# 1960 Corvette: Service Bulletin: Generator Belt Misalignment

**Subject:** Generator Belt Misalignment  
**Model and Year:** 1960 Corvette  
**Source:** G.M. of Canada Service Bulletin  
**Bulletin No:** NA  
**Section:** NA  
**Date:** April 30, 1960

## GENERATOR BELT MISALIGNED DUE TO IMPROPER INSTALLATION OF GENERATOR BRACKET - 1960 Corvette Equipped With Fuel Injection

Fig. 20.

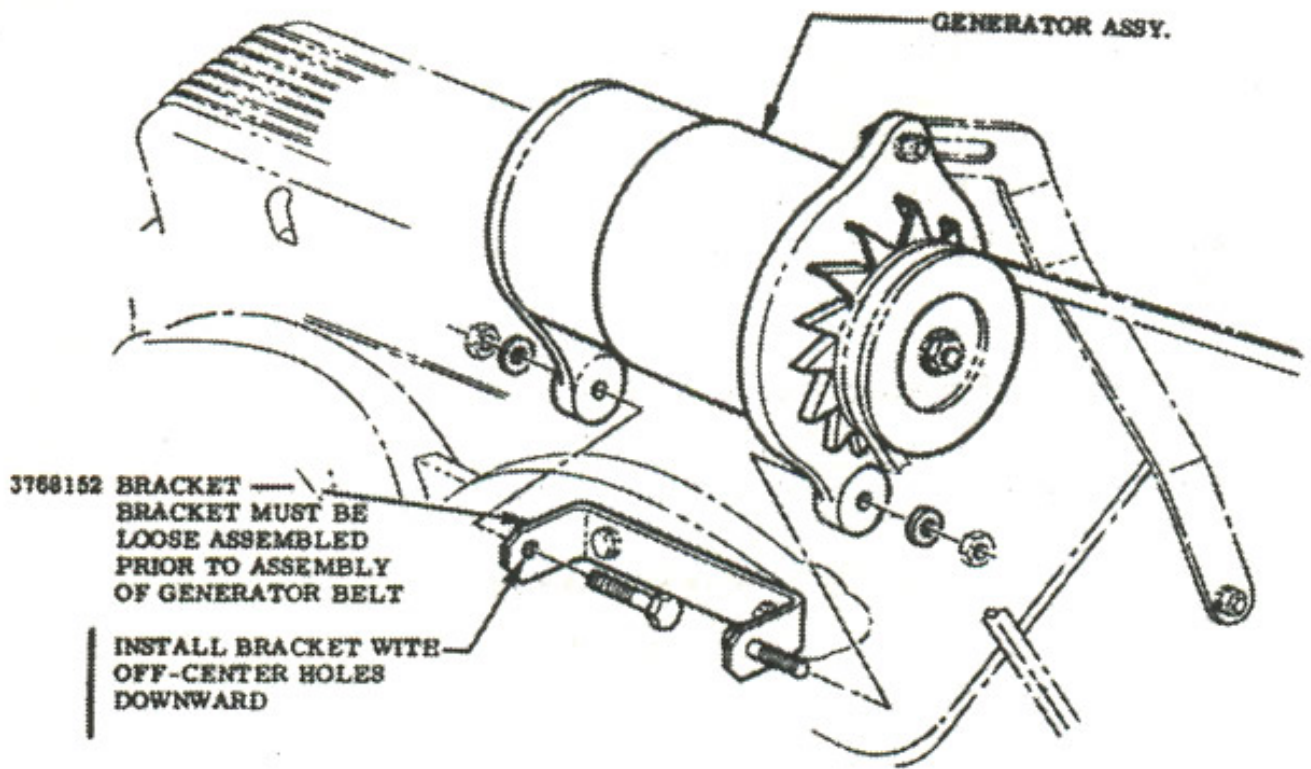
In the event difficulty is experienced with fan belt misalignment on fuel injection Corvettes only, check to see that the generator mounting bracket is assembled properly. When bracket is installed upside down, the generator is moved 1/4" too far forward. The bracket must be installed with the off-centre holes downward, as shown in Fig. 20.
